OAK CONTRACTING LLC
Builders

ADDENDUM NO. 2

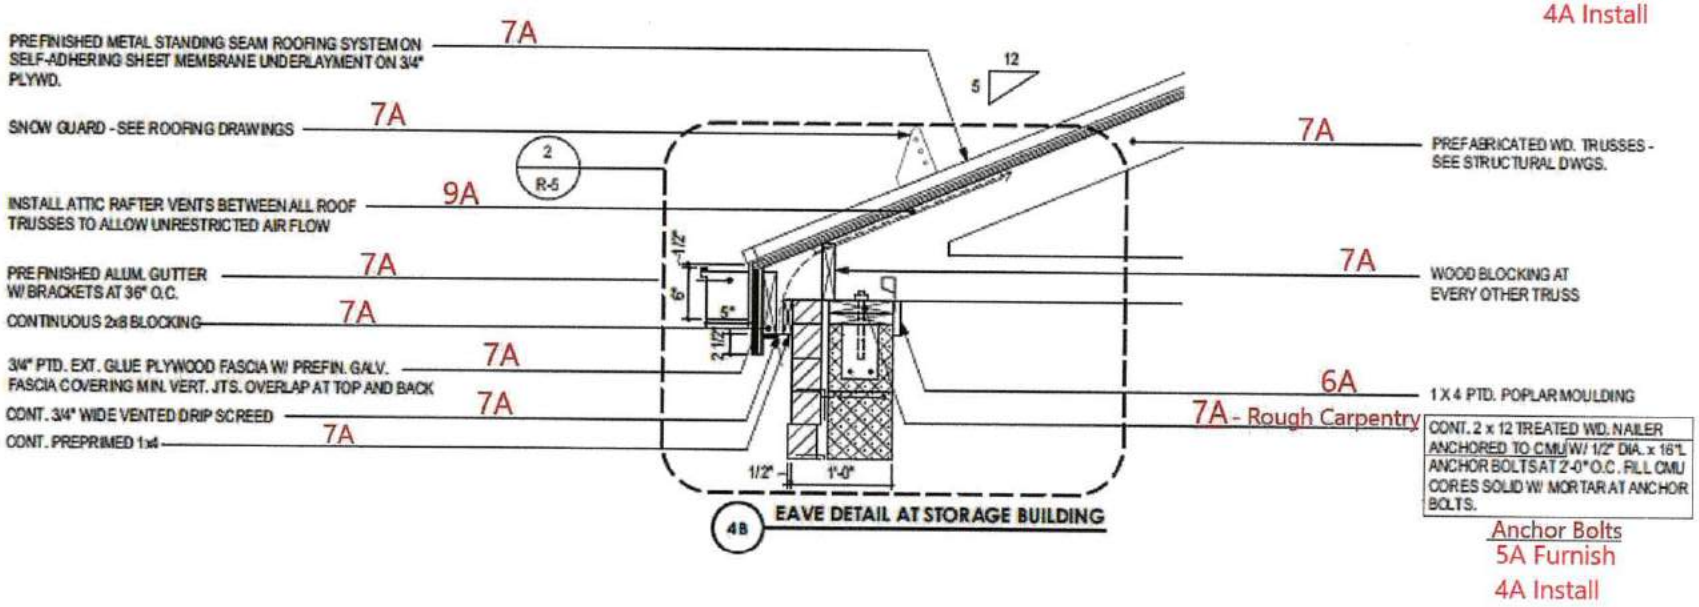
Scope Clarification Detail #05
Typical throughout all details.

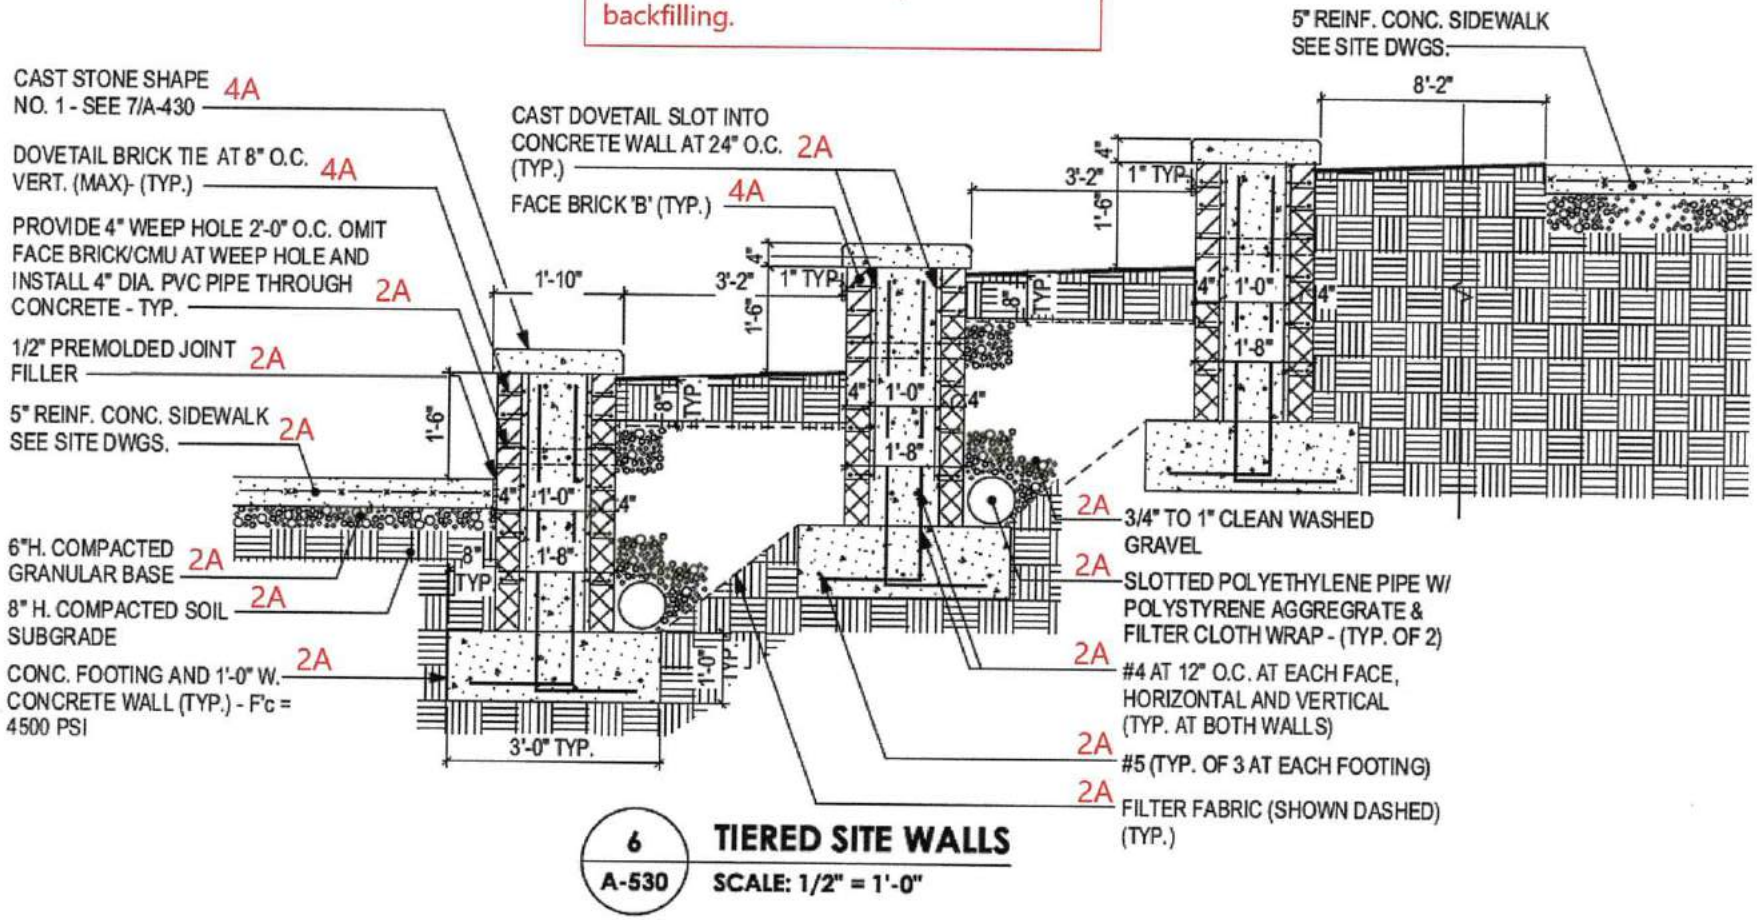
Scope Clarification Detail #14

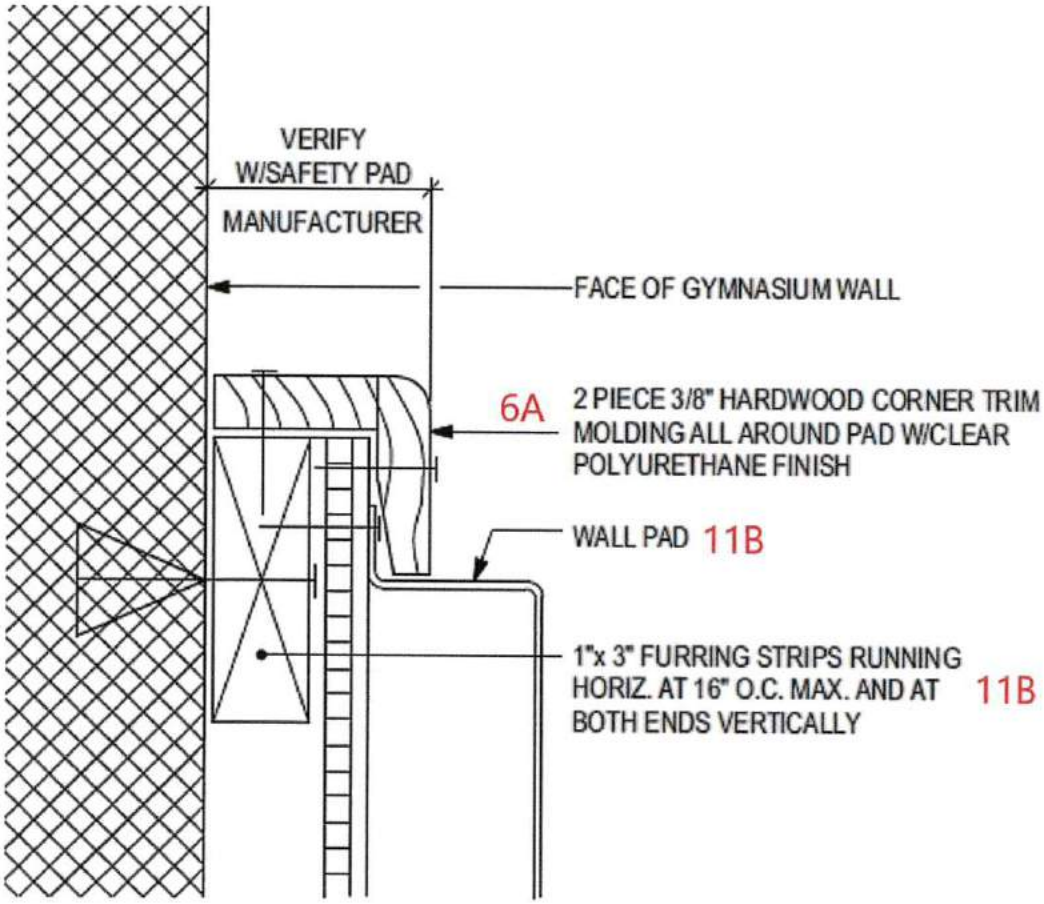
Scope Clarification Detail #16

Addendum #2

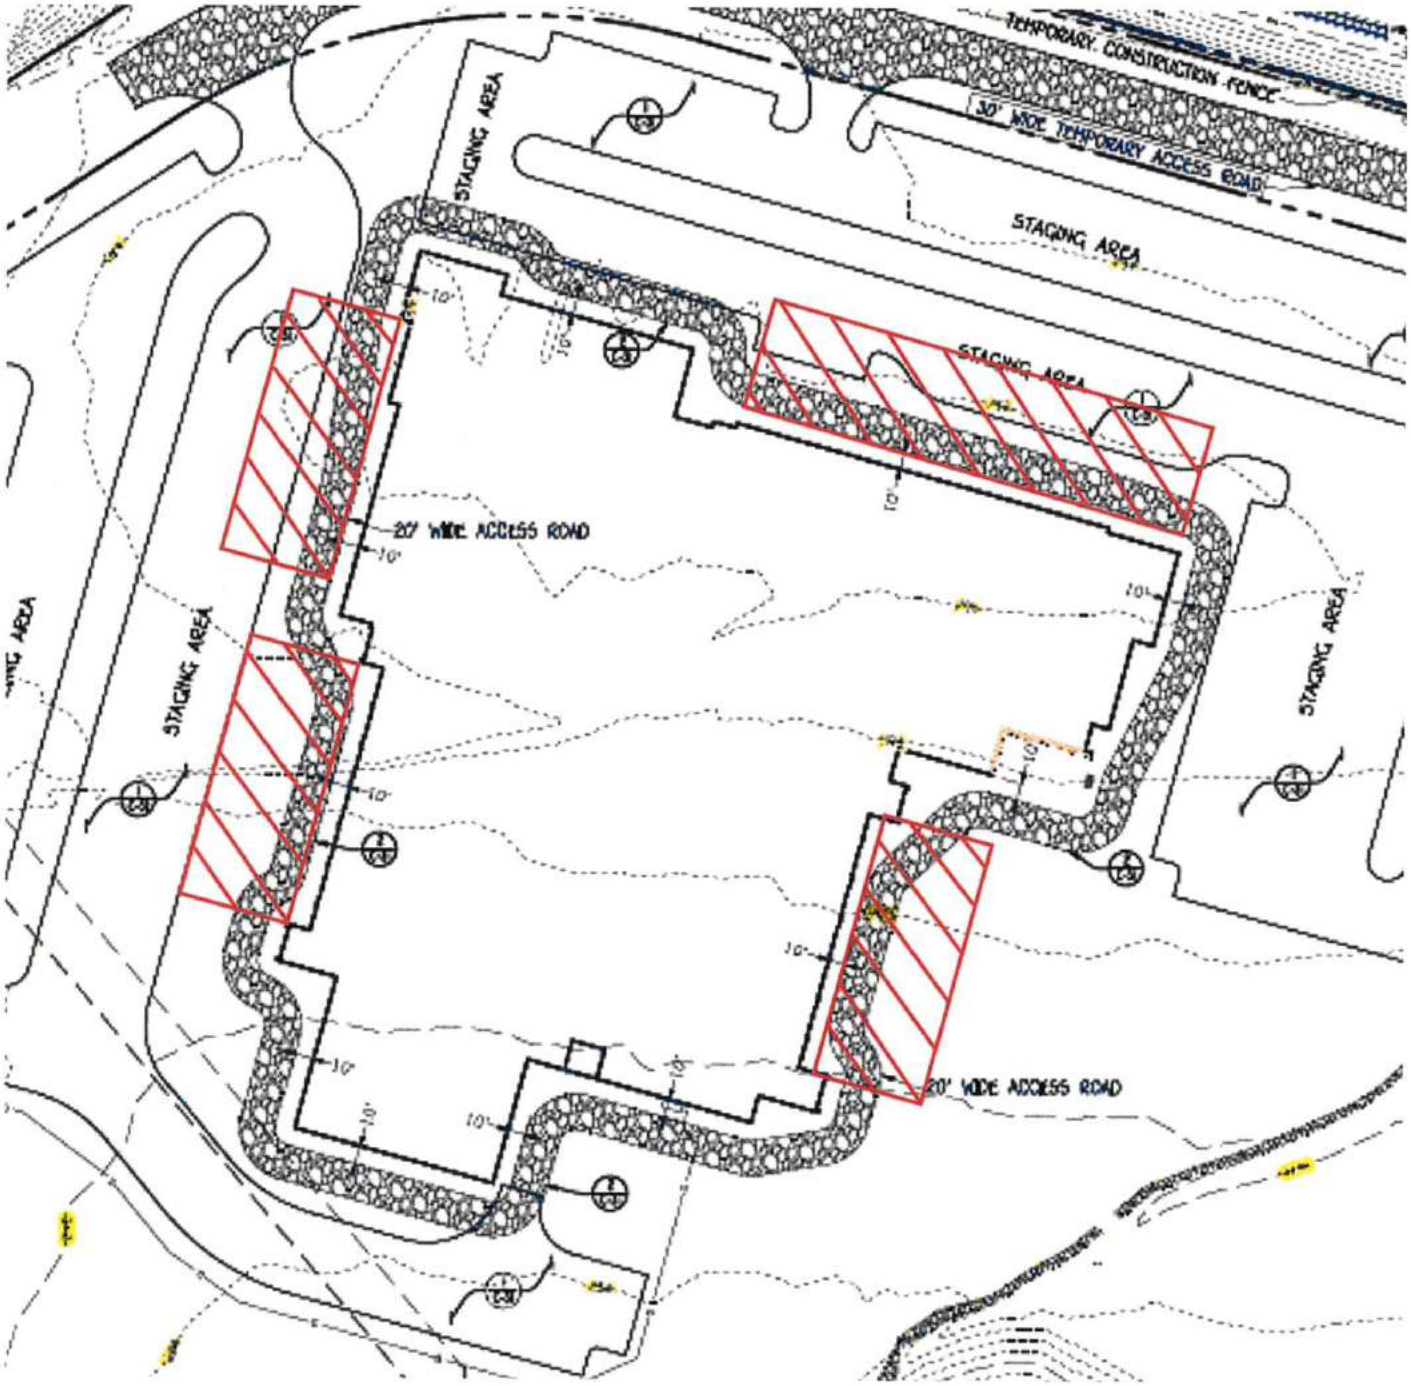
The 5A Contractor is responsible to locate his crane as required to erect all steel from outside the building footprint. Potential crane locations may include but are not limited to the hatched areas shown on this scope clarification detail. Refer to Contract Package 5A Steel item 2.22.

Addendum #2

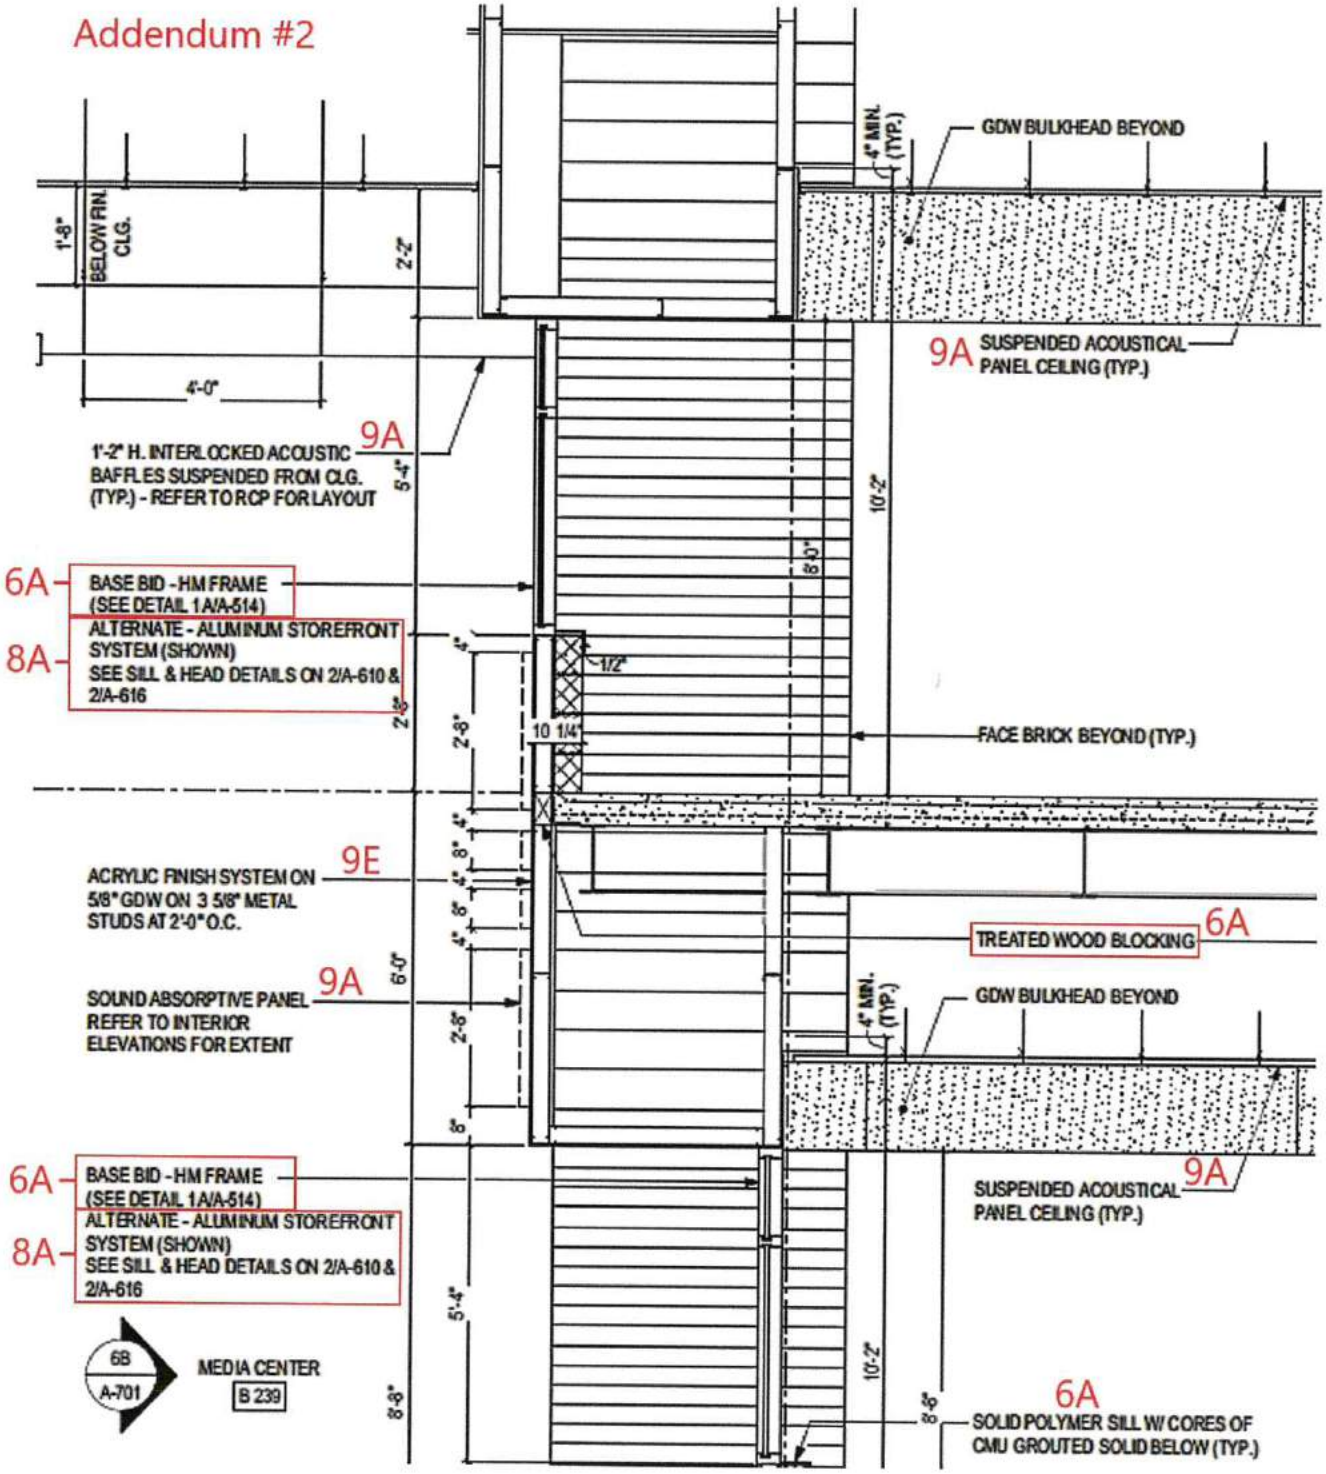
Scope Clarification Detail #18

Addendum #2

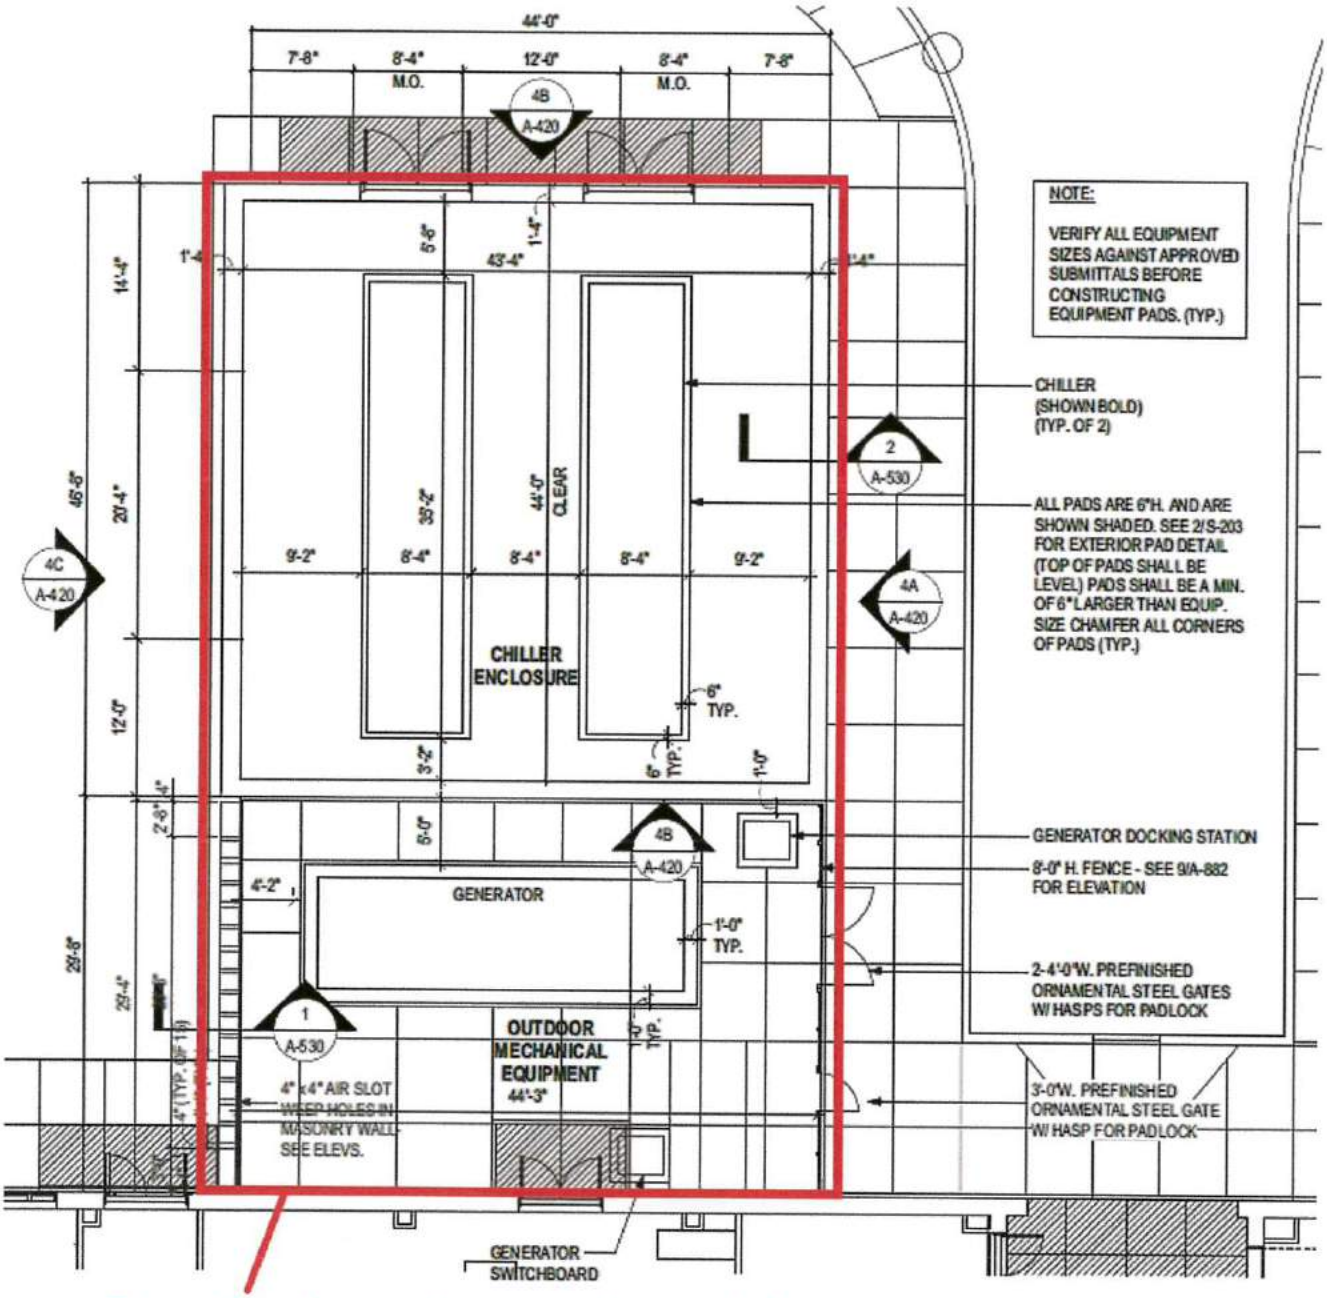
Scope Clarification Detail #19
